PROJECT: ADDENDUM NO.: 1

Willow Lake School Addition

OWNER: DATE OF ISSUANCE: Willow Lake School District 12-3 February 10, 2023

CO-OP Architecture

DEMOLITION PLAN - AREA A

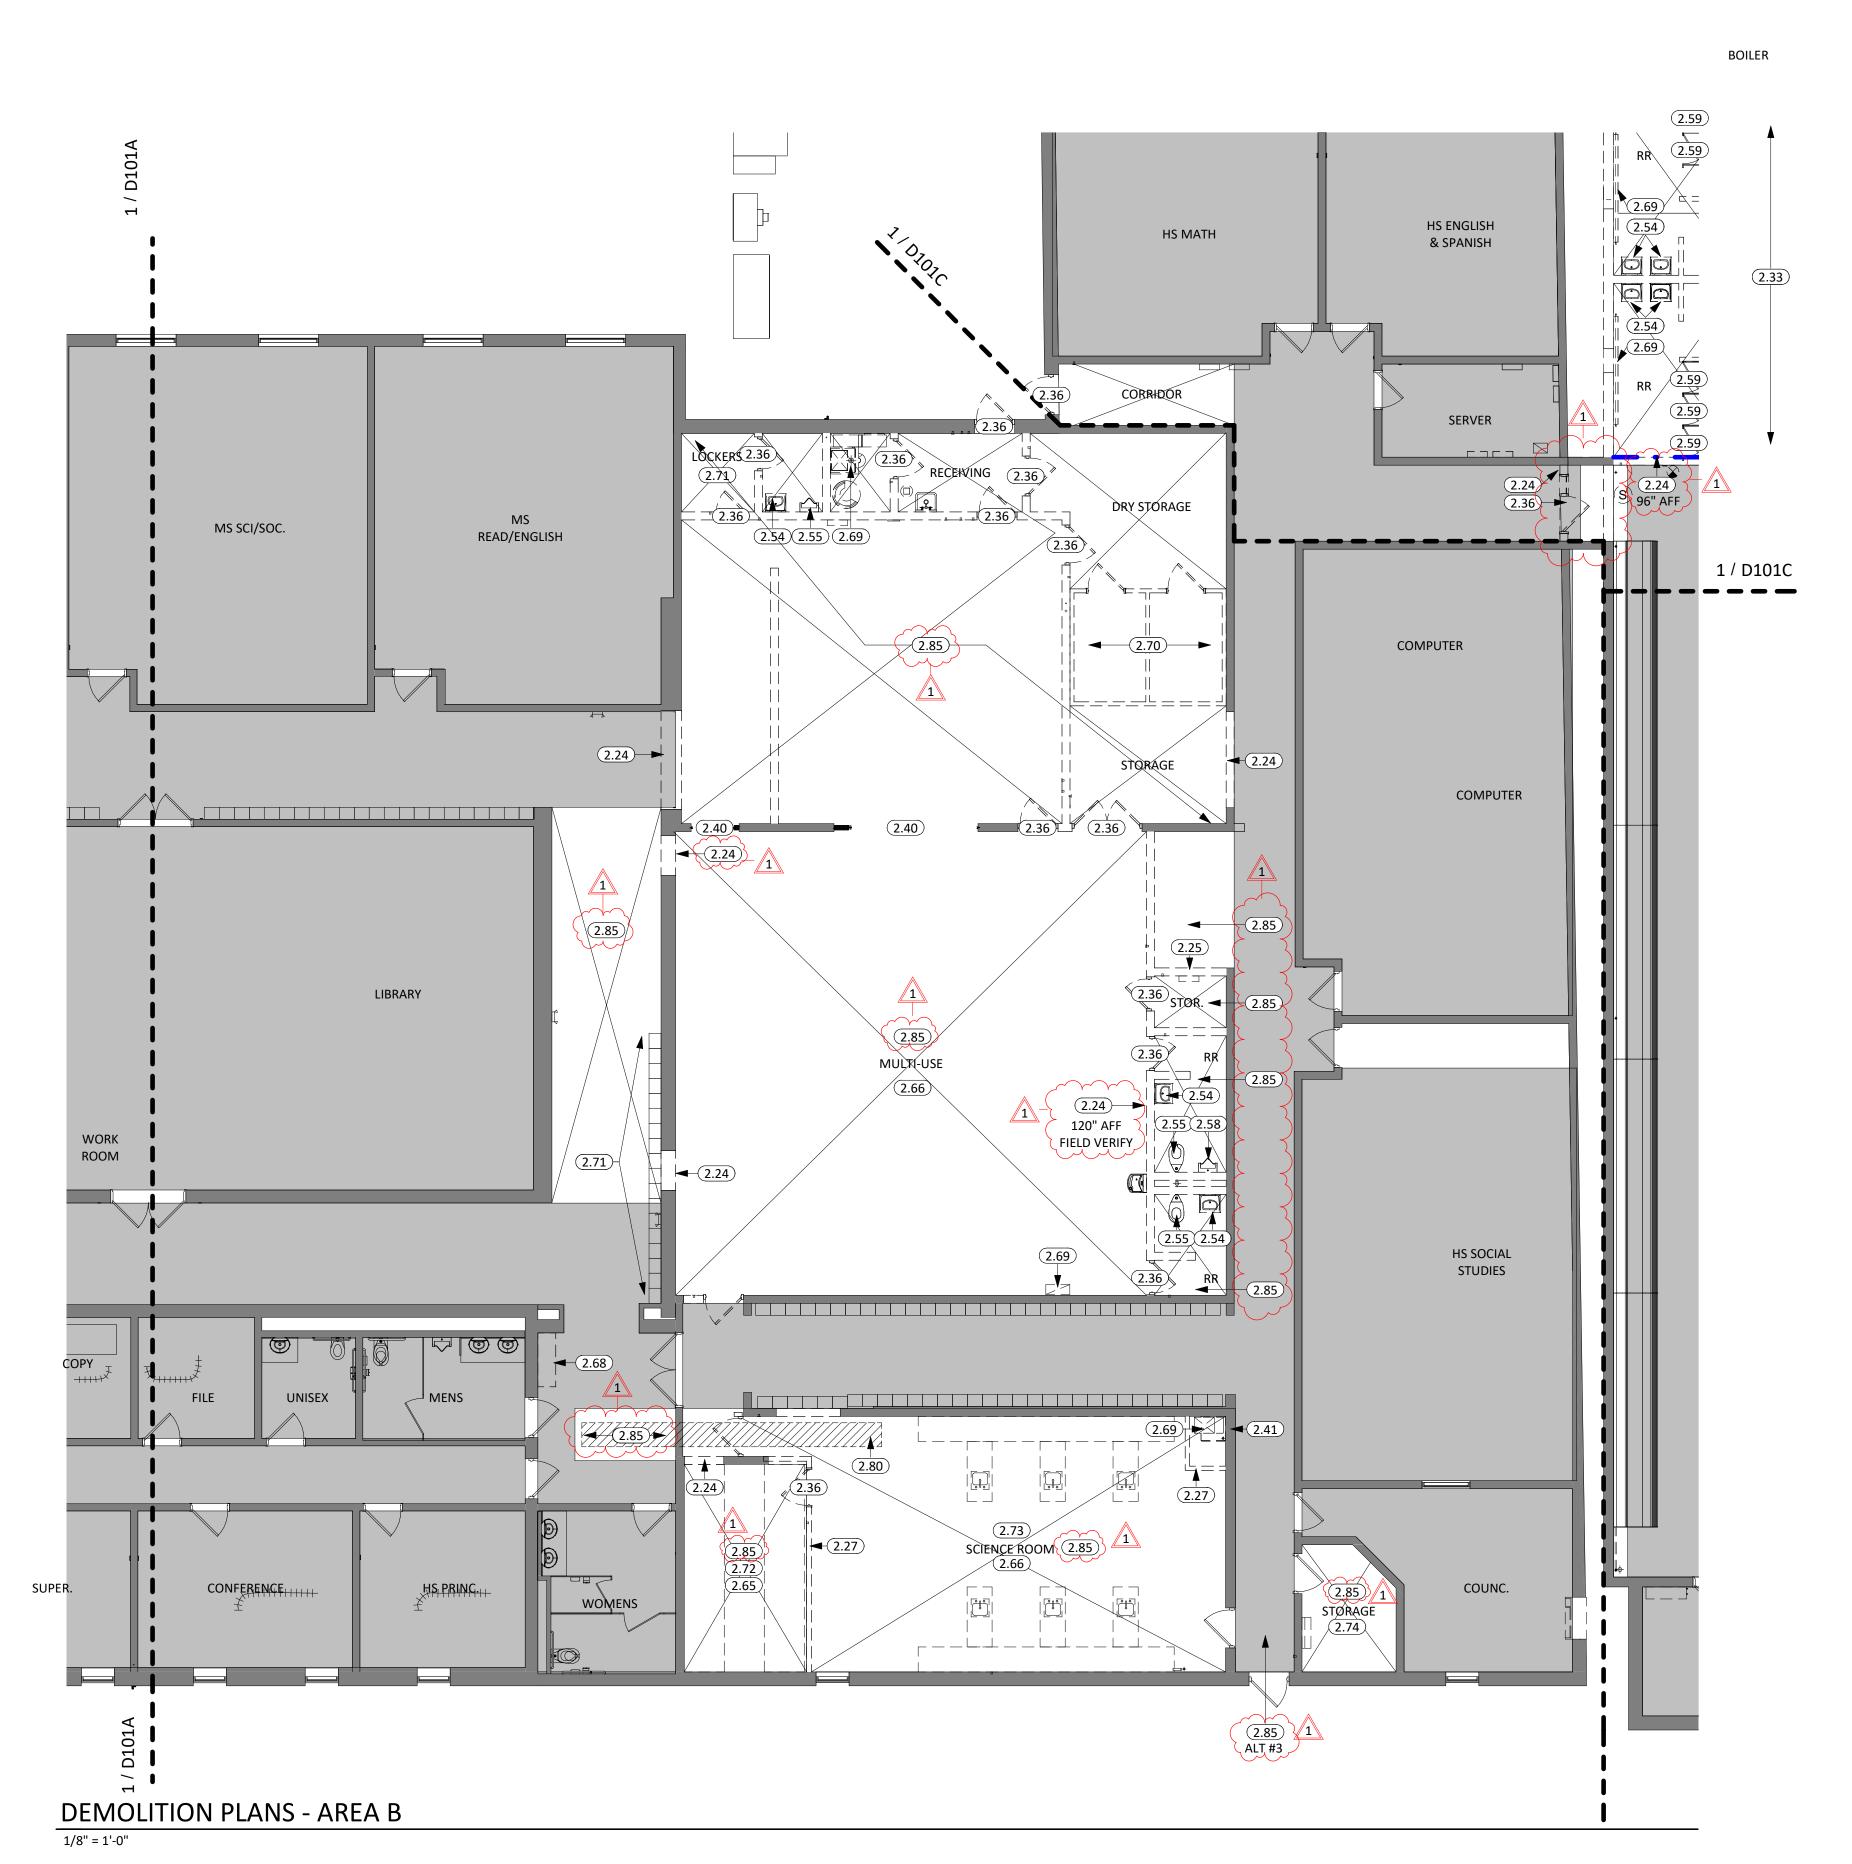
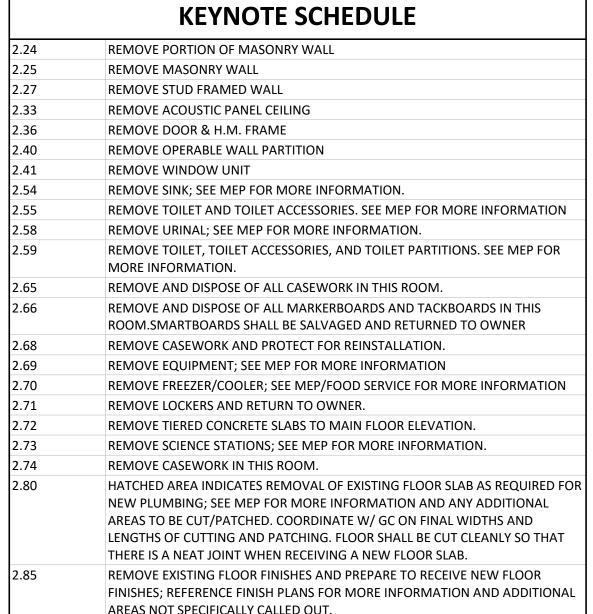
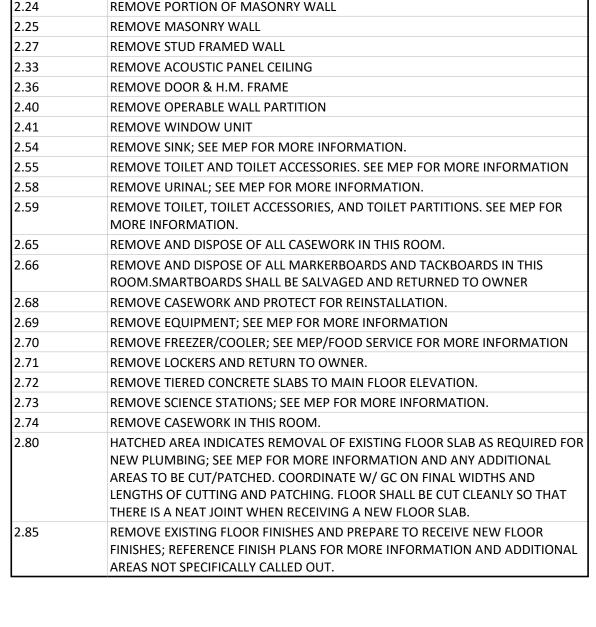
- 5) Sheet S302 BRACED FRAME ELEVATIONS
 - a. See clouded areas for revisions.
- 6) Sheet D101A DEMOLITION PLAN AREA 'A'
 - a. Added clarifying notes regarding floor finish removal.

- b. Added clarifying notes regarding floor finish removal for Alternate 3
 - c. Expanded Demolition Legend to clarify masonry wall types as typical demolished walls unless noted otherwise.

DEMOLITION PLAN - AREA B

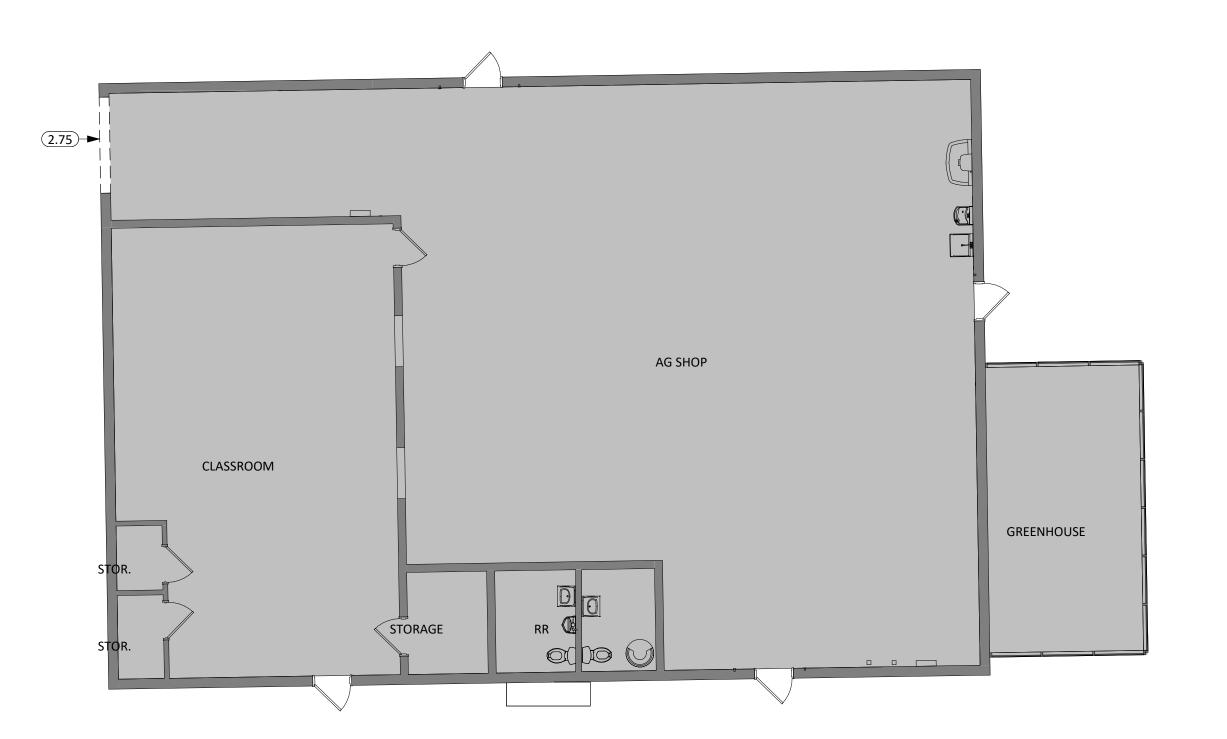
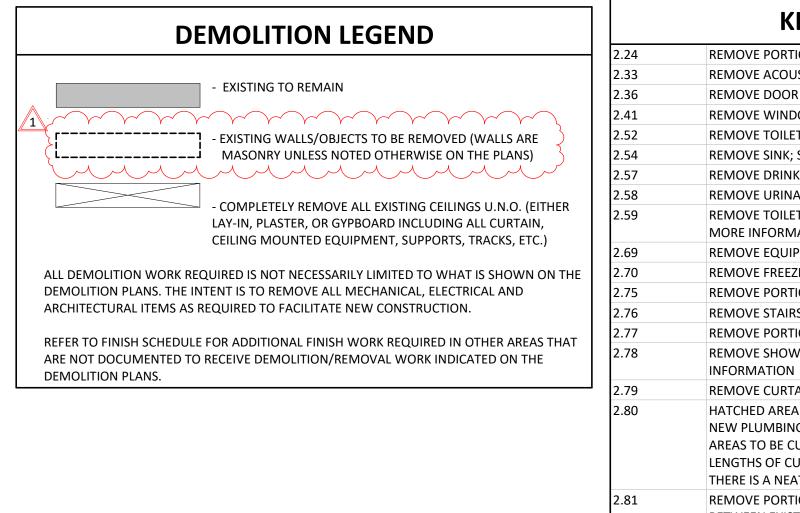
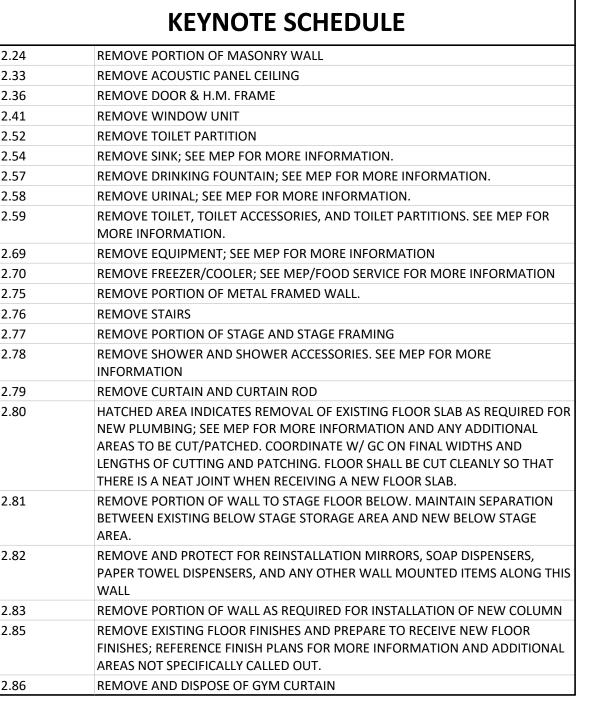
- 7) Sheet D101B DEMOLITION PLAN AREA 'B'
 - a. Added clarifying notes regarding floor finish removal.
 - b. Added clarifying notes regarding floor finish removal for Alternate 3

- c. Expanded Demolition Legend to clarify masonry wall types as typical demolished walls unless noted otherwise.
 - d. Added note clarifying height to remove wall in current Multi-Use room.

DEMOLITION PLAN - AREA C

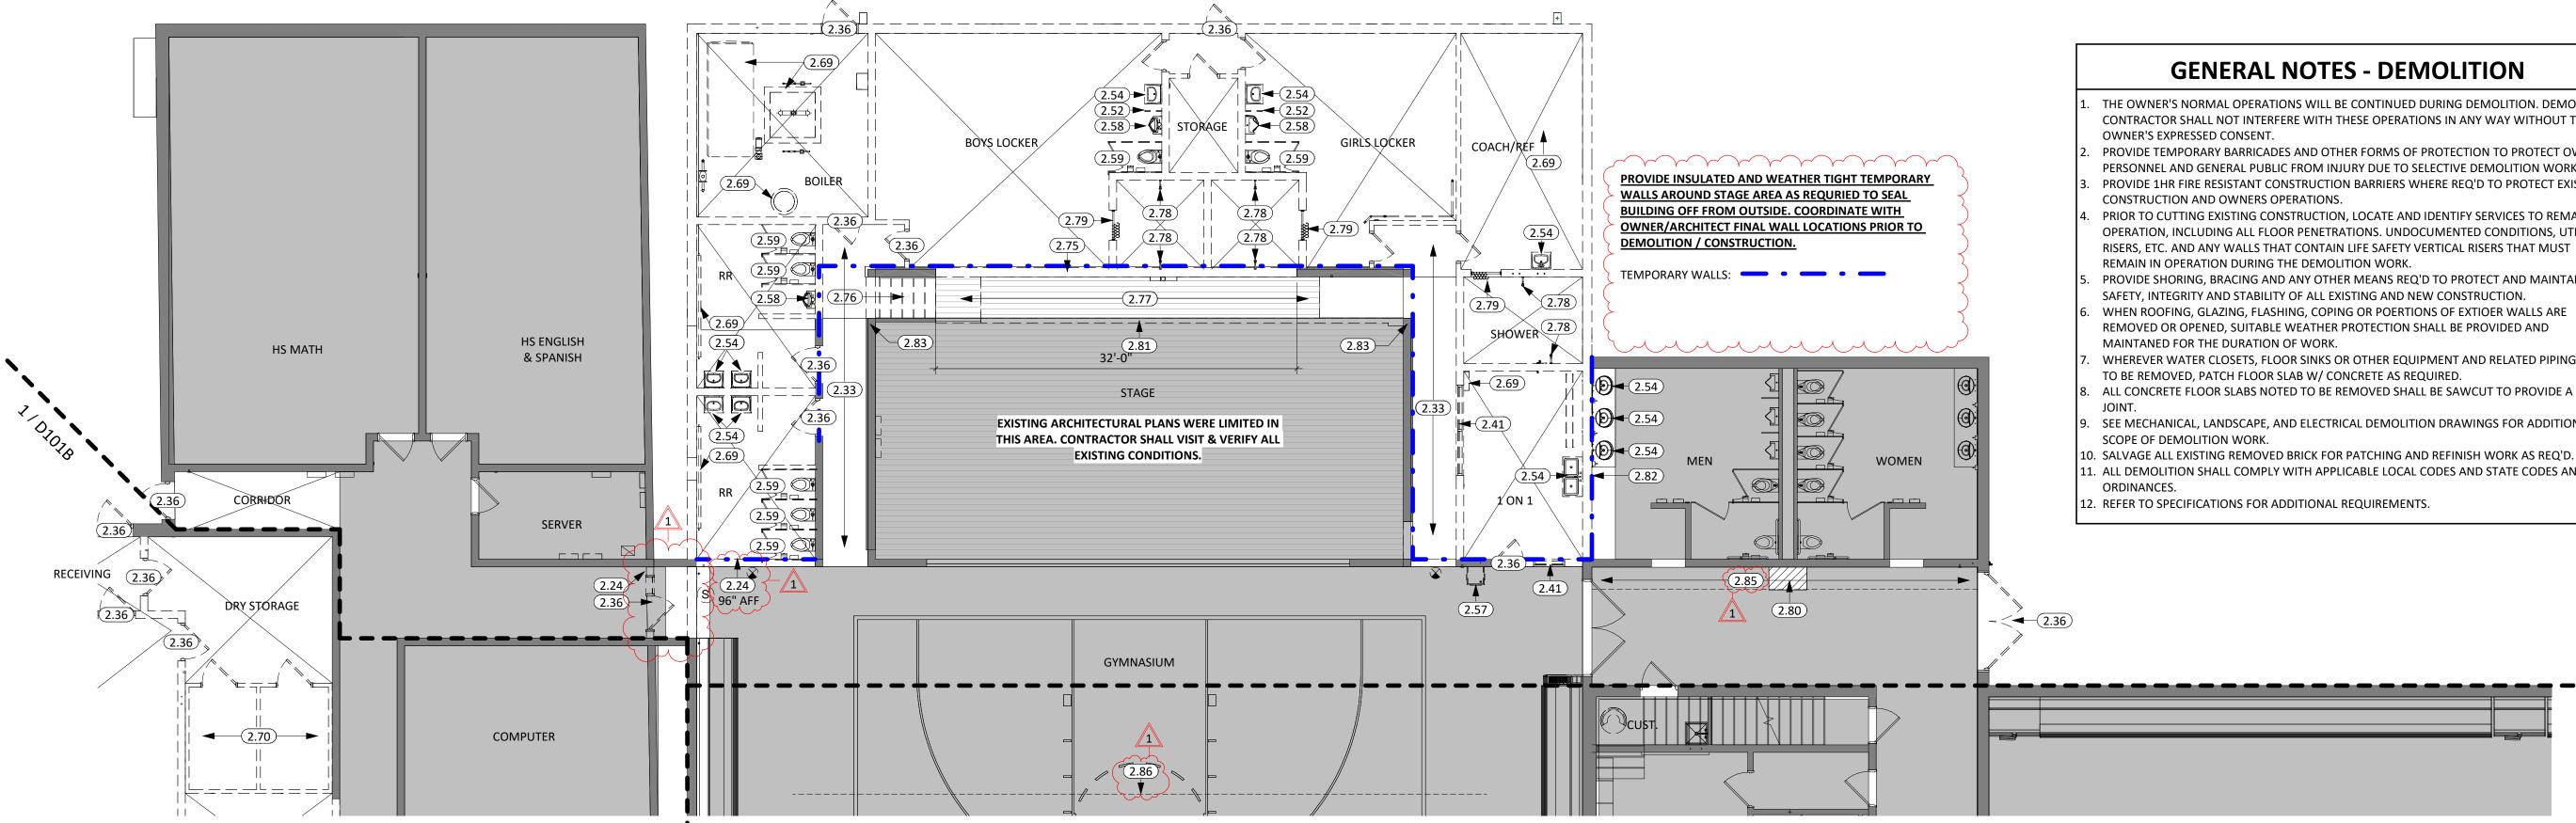
- 8) Sheet D101C DEMOLITION PLAN AREA 'C'
 - a. Added clarifying notes regarding floor finish removal.
 - b. Expanded Demolition Legend to clarify masonry wall types as typical demolished walls unless noted otherwise.

- c. Added note clarifying height to remove wall at future commons corridor.
 - d. Revised existing walls to remain in lieu of being demolished.
 - e. Clarified extents of temporary walls
